Final Main Installation Focused Feasibility Study Report

Defense Depot Memphis, Tennessee U.S. EPA I.D. Number TN4210020570

July 2024

U.S. Army Corps of Engineers, Mobile District Contract No. W91278-16-D-0061 Task Order No. W9127819F0535

Figure 18 Memphis Aquifer CVOC Concentrations, April 2021

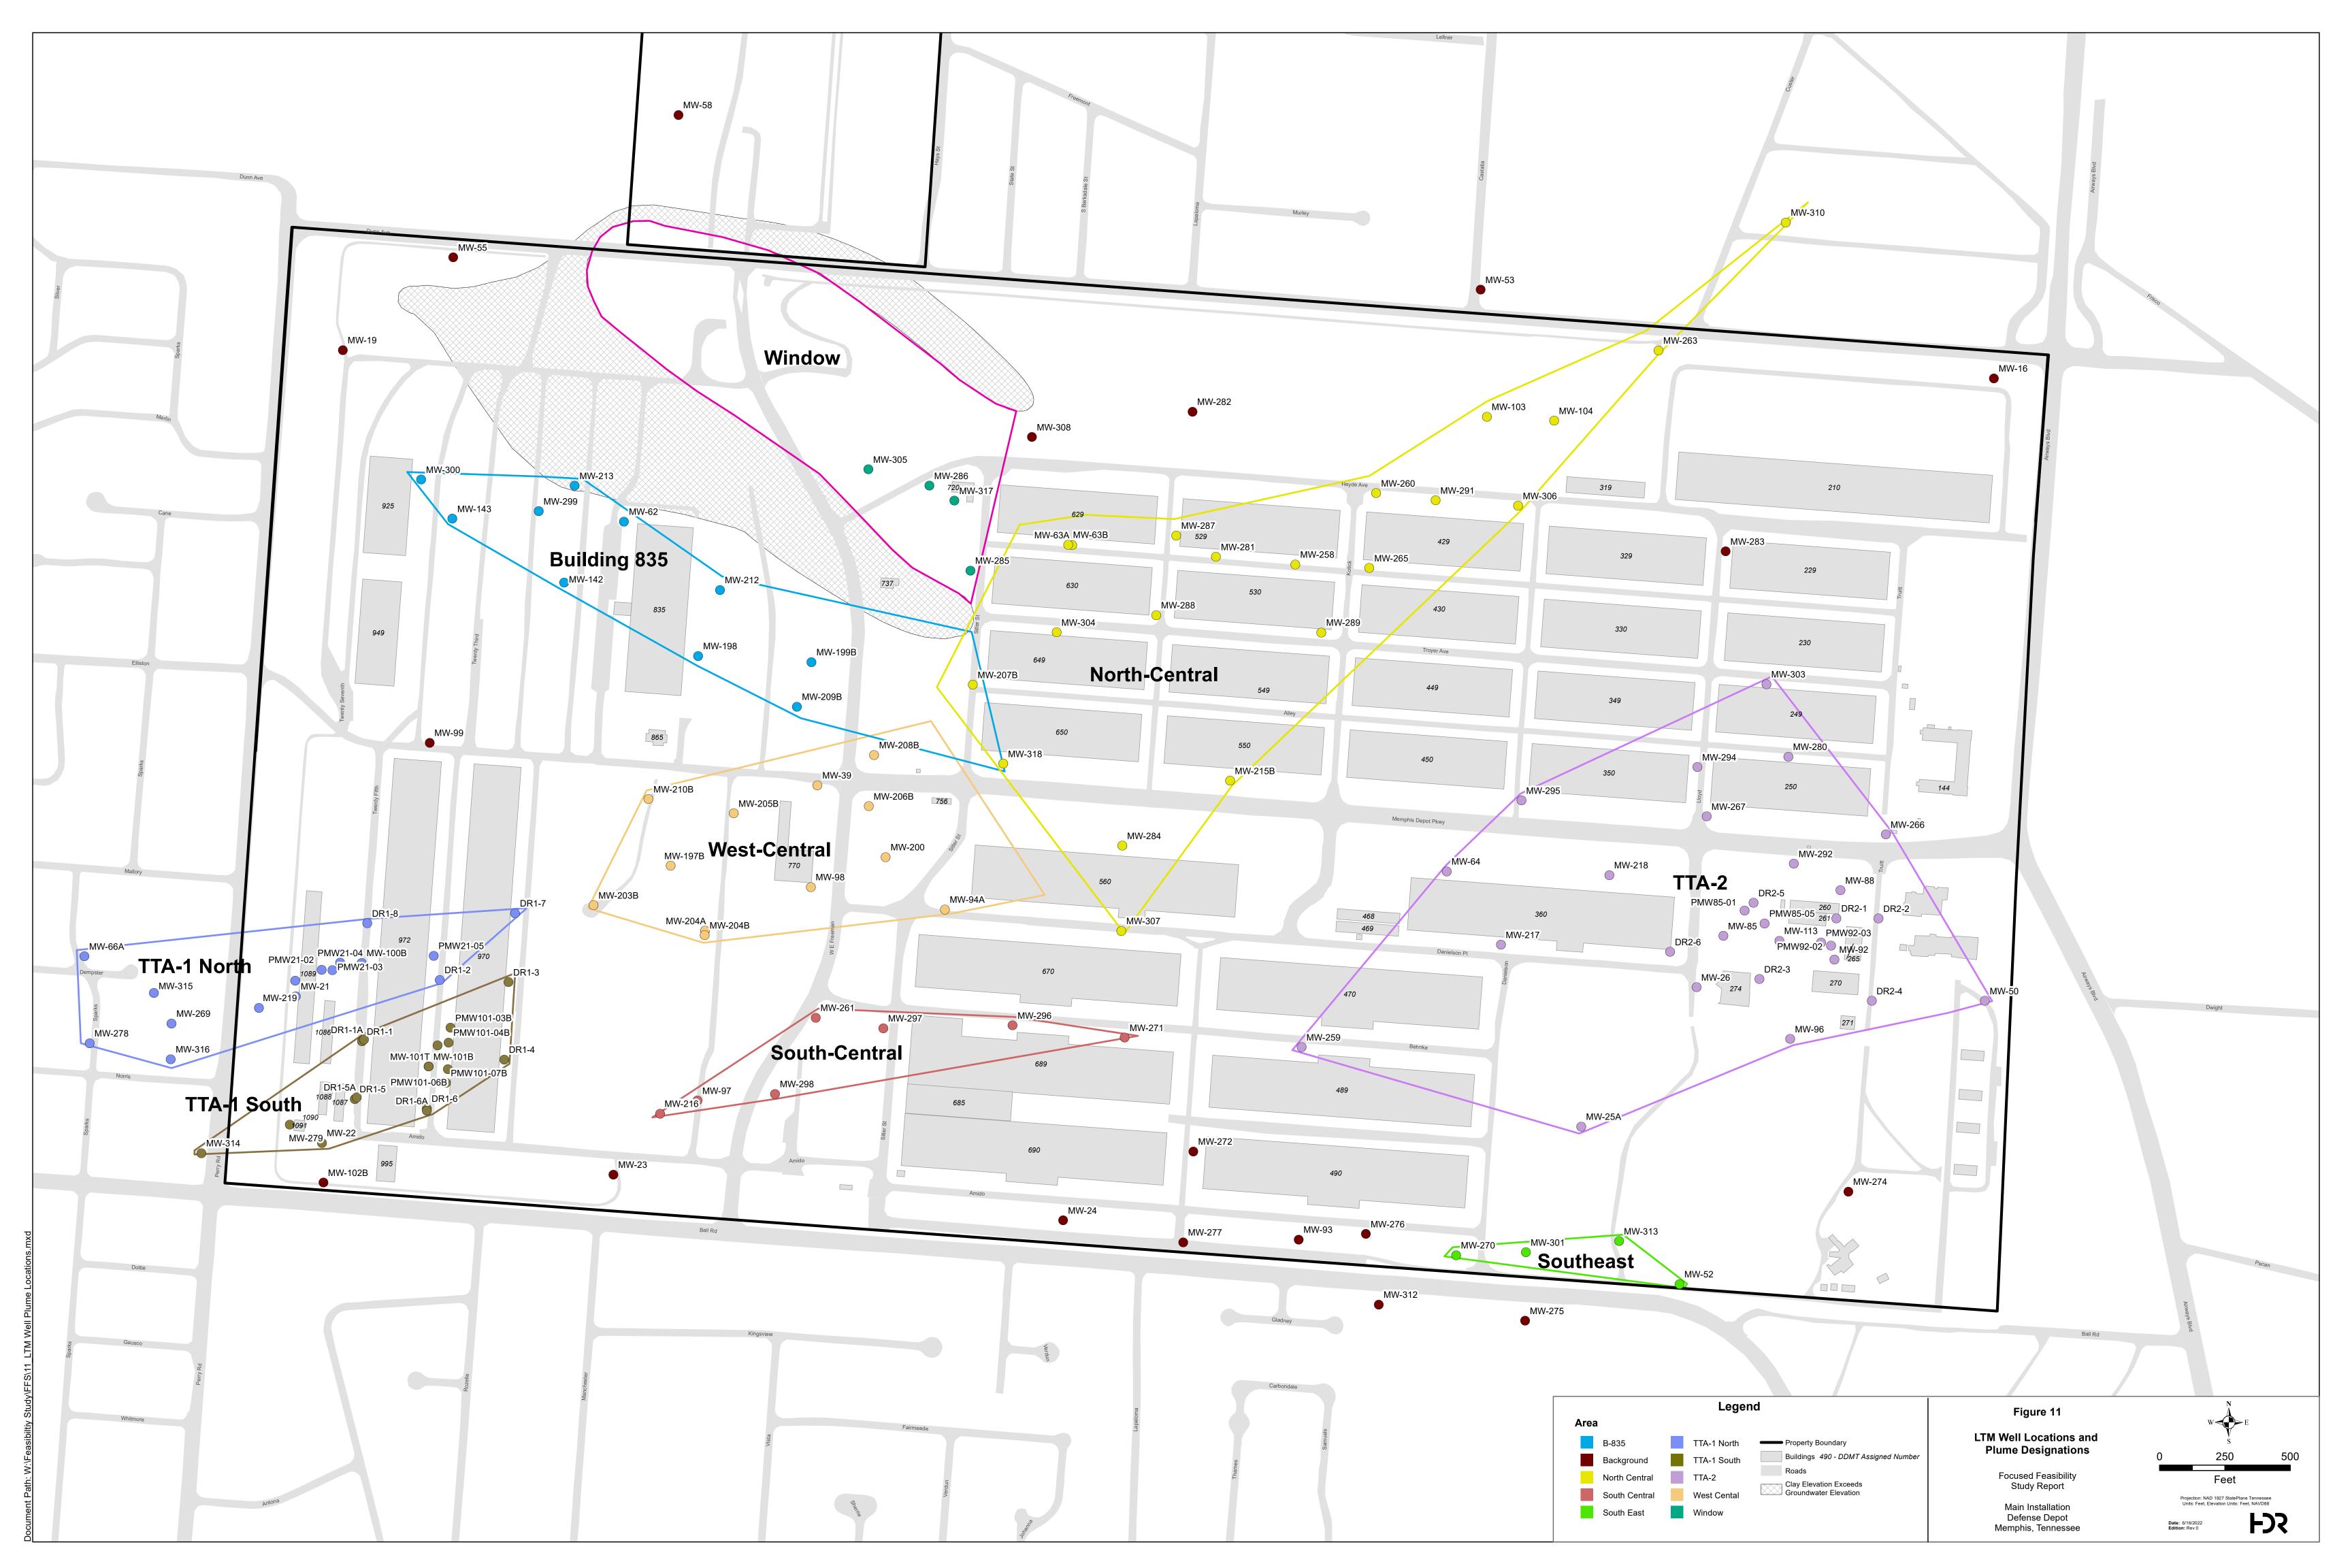
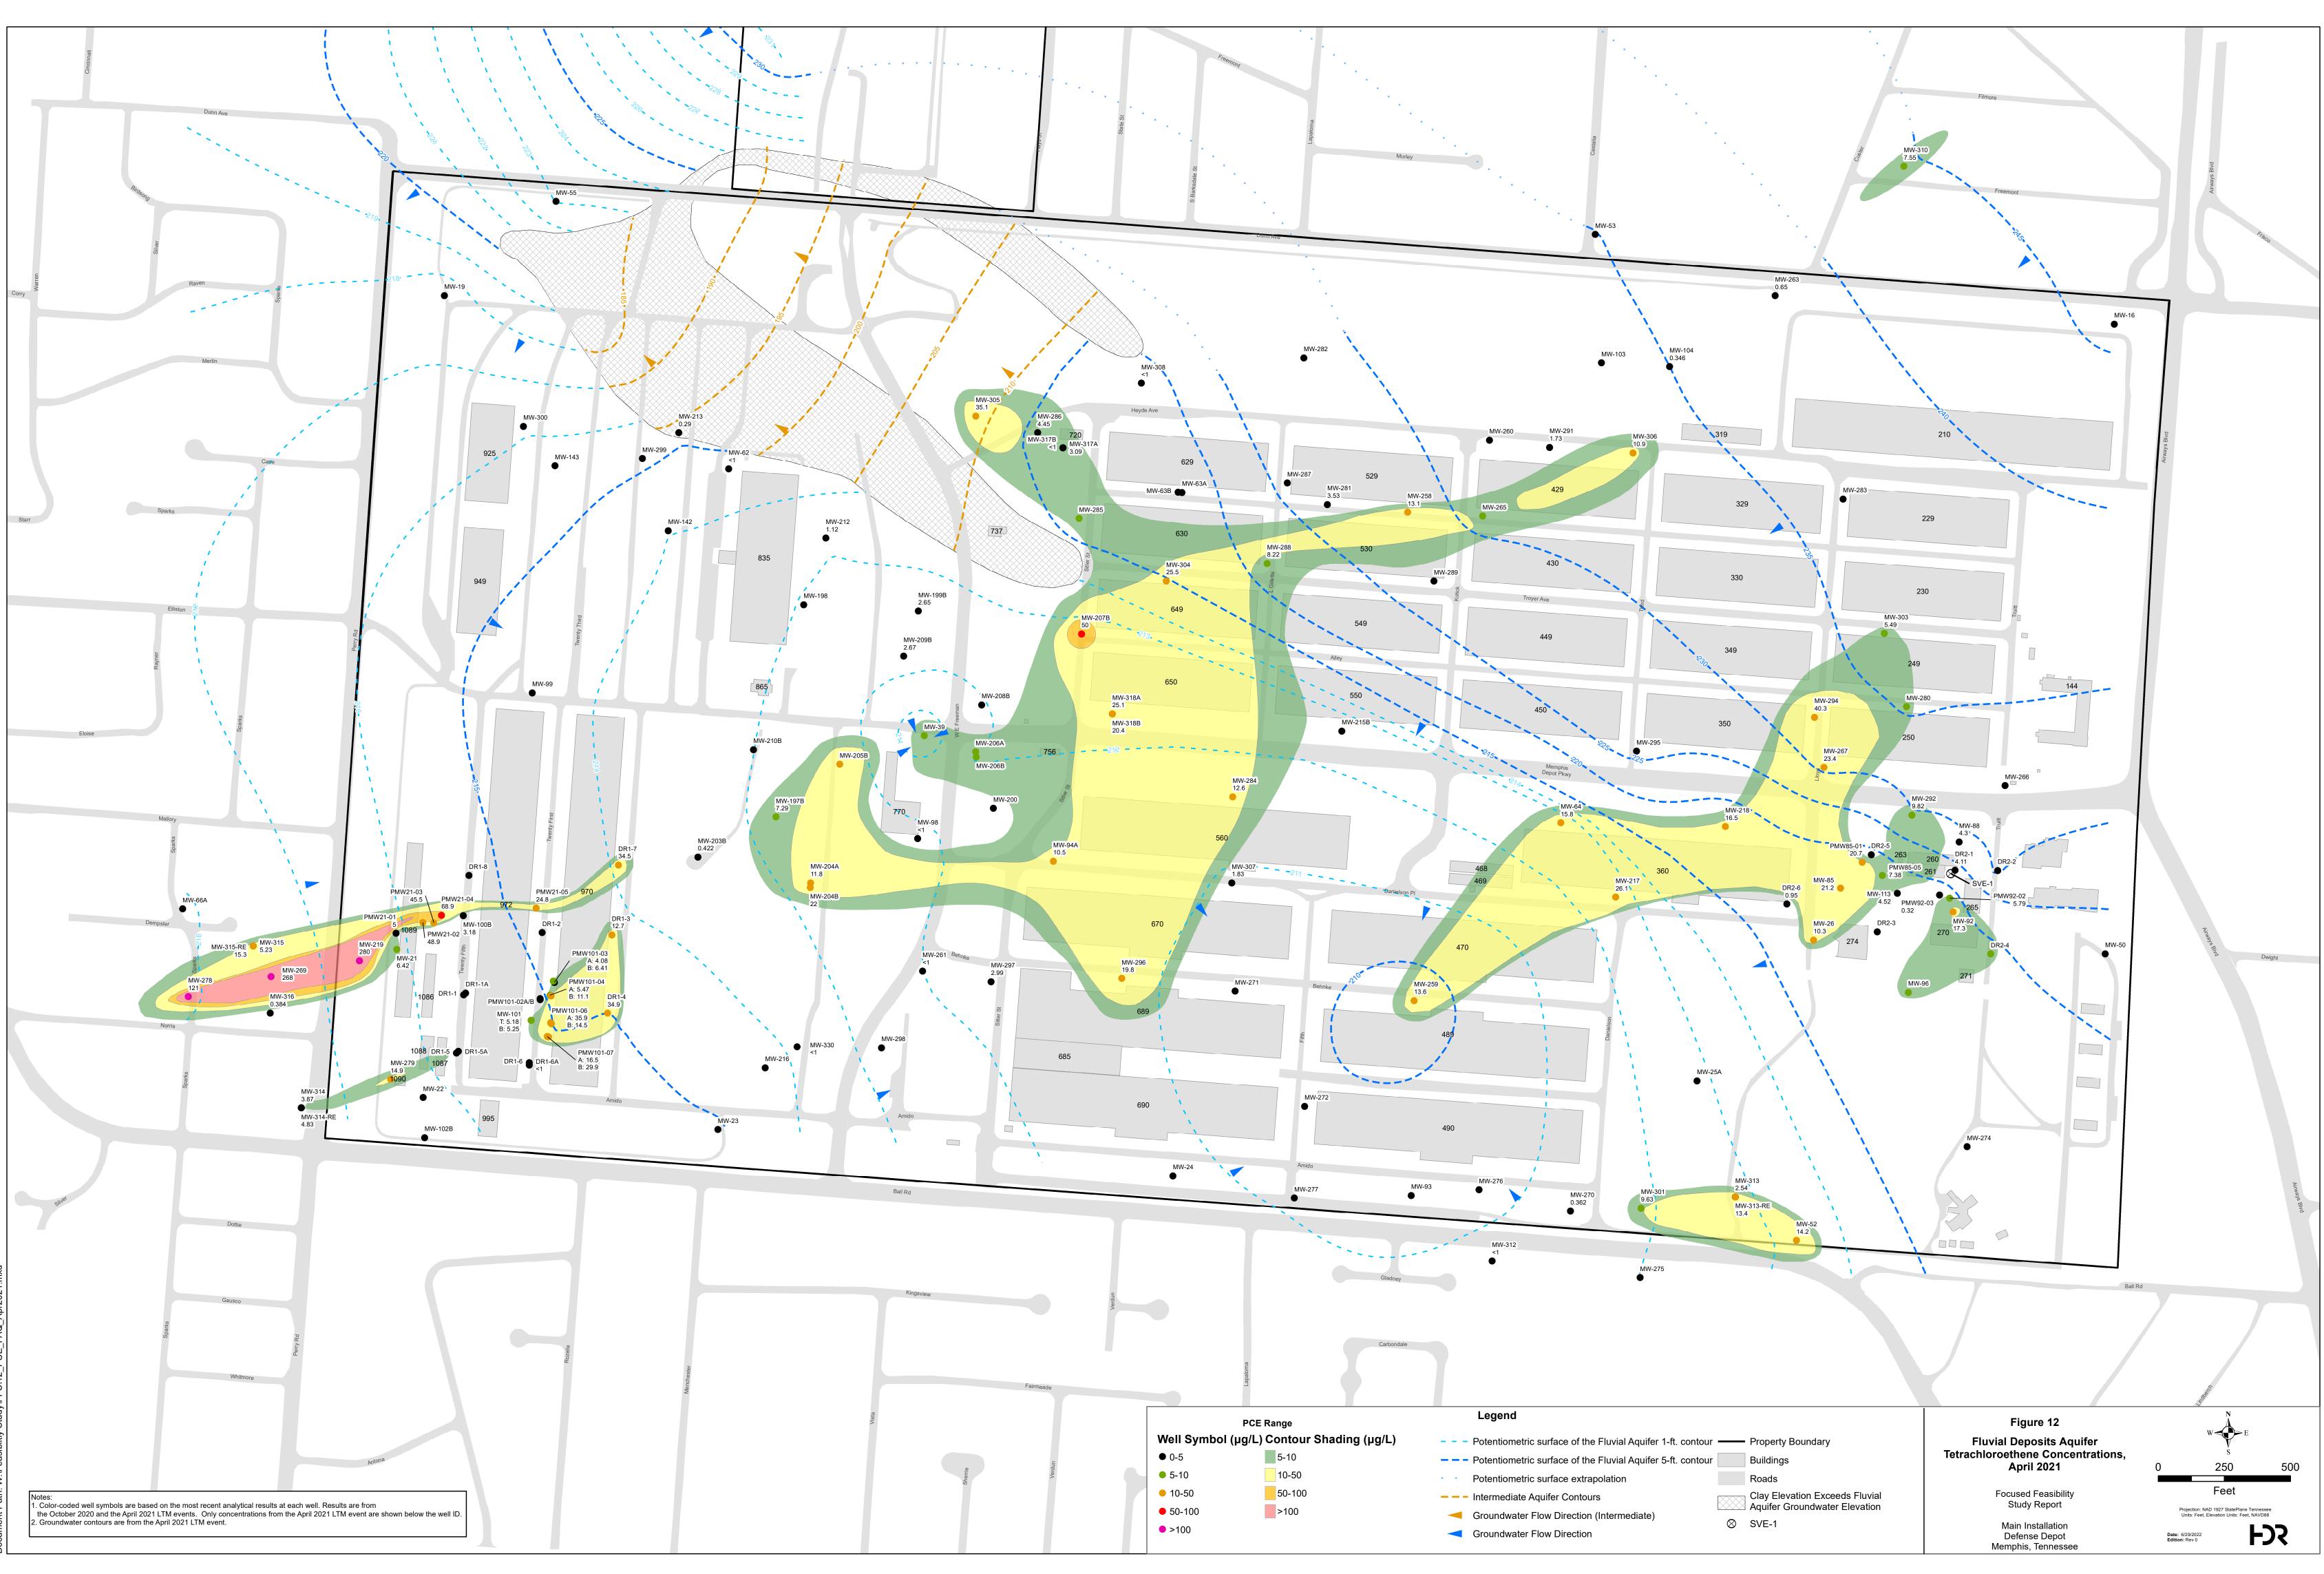
Moreover, Figure 18 shows chlorinated VOC detections in the Memphis Sand Aquifer. As part of the monitoring plan, downgradient monitoring locations will need to be installed.

- 12. Section 1.2.6.2.8, Hydraulic Connections IAQ and MAQ, Page 1-15: The final sentence of this section states that there is no plume in the MAQ; however, according to Figure 18 (Memphis Aquifer CVOC Concentrations, April 2021) tetrachloroethylene (PCE) was detected above the USEPA Maximum Contaminant Level (MCL) of 5 μg/L in monitoring wells MW-254 and MW-140, which are in the northeast portion of the MI. It should be noted there is no MAQ well to the southwest to bound these PCE exceedances. Based on the proximity of MW-254 and MW-140, a potential undefined PCE plume appears to be present in the MAQ in the northwest portion of the MI. Please revise the text to discuss this potential PCE plume in the MAQ.

12. Section 1.2.6.2.8, Hydraulic Connections – IAQ and MAQ, Page 1-15: The final sentence of this section states that there is no plume in the MAQ; however, according to Figure 18 (Memphis Aquifer CVOC Concentrations, April 2021) tetrachloroethylene (PCE) was detected above the USEPA Maximum Contaminant Level (MCL) of 5 μg/L in monitoring wells MW-254 and MW-140, which are in the northeast portion of the MI. It should be noted there is no MAQ well to the southwest to bound these PCE exceedances. Based on the proximity of MW-254 and MW-140, a potential undefined PCE plume appears to be present in the MAQ in the northwest portion of the MI. Please revise the text to discuss this potential PCE plume in the MAQ

As stated in Response SC5, contaminant concentrations in the MAQ in the downgradient area of the plume, within the erosional window, are only slightly above the MCL. Concentrations in upgradient wells in the MAQ and lower IAQ are not significantly higher (see Figure 10 of the FFS). Groundwater modeling estimated concentrations would decrease below 1 μ g/L within approximately 2,000 ft from the MI. Response SC5 states that active remediation at Building 720, within the window, will "reduce concentrations in downgradient wells including MAQ wells ...".
